Report of the Strategic Director Place to the meeting of Bradford East Area Committee to be held on 13 July 2023

BRADFORD EAST AREA-WIDE TRAFFIC REGULATION ORDER - OBJECTIONS

This report considers objections received to the previously advertised Bradford East Area-Wide Traffic Regulation Order

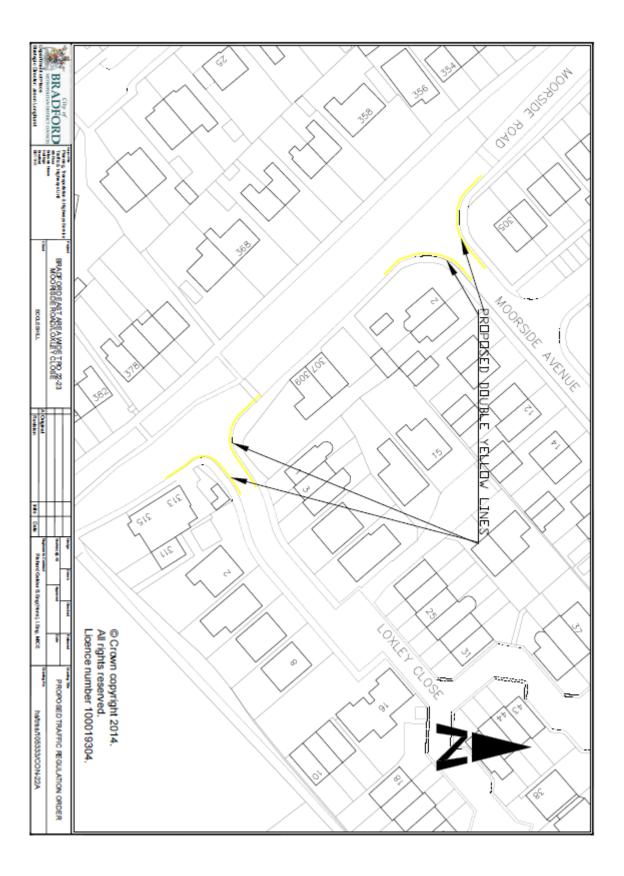
Objectors concerns	Officer comments
Moorside Road/Loxley Close, Eccleshill (Ward	
<u>10)</u>	
Dwg No. HS/TRSS/105333/CON-22A	
Number of objectors 1	
Objector – A resident has a driveway and has	This request would have no detrimental
requested that the proposed double yellow lines	impact on the original scheme and as such
be scaled back so as not to cover the driveway.	it is recommend that this element of the
The objector points out that they generally have	proposal be amended accordingly.
two vehicles often parking on the road entrance to	
the driveway.	
Moorside Road/Delverne Grove, Eccleshill (Ward	Moorside Road/Delverne Grove
<u>10)</u>	
Dwg No. HS/TRSS/105333/CON-21A	The double yellow lines are proposed to
Number of objectors 3	attain appropriate sight lines for vehicles
Objector 1-The objector states this space has	exiting the junction. The proposed lines are
been used by residents for parking over a long	within 10m of the junction and as such

period of time and suggests the restrictions would	parking should not take place within this
be better placed on the opposite side of the road.	area.
	Furthermore, the proposed double yellow
	lines optimise pedestrian safety by ensuring a clear crossing point at the
	junction mouth.
	junionon mount.

- 10.1 That the objection in relation to Moorside Road/Loxley Close be upheld and the proposal modified to reduce the length of proposed waiting restrictions on Loxley Close in accordance with Drawing No. HS/TRSS/105333/CON-22B, attached as Appendix 2.
- 10.2 That the objections in respect of Moorside Road/Delverne Grove be overruled and the Bradford East Various Sites Order 2022/23 be sealed and implemented as advertised.
- 10.3 That the objectors be informed accordingly.

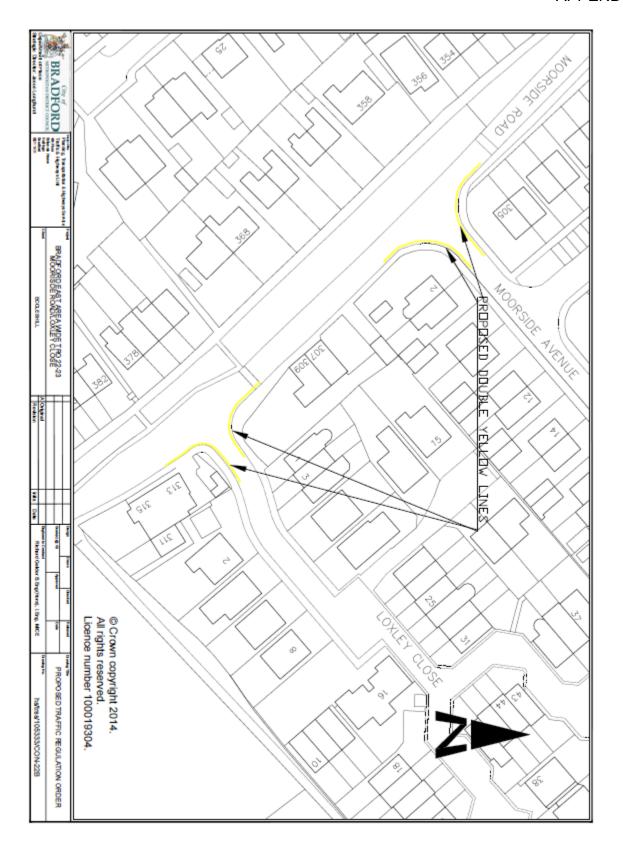
Objectors 2&3 - The objectors state this space has
been used as parking by local residents without
any issue for road safety and argue parking
space is to be further reduced with a resident on
Moorside Road building a wall outside their
property.

COMMENTS AS ABOVE

There is no evidence of an obstruction in the highway.
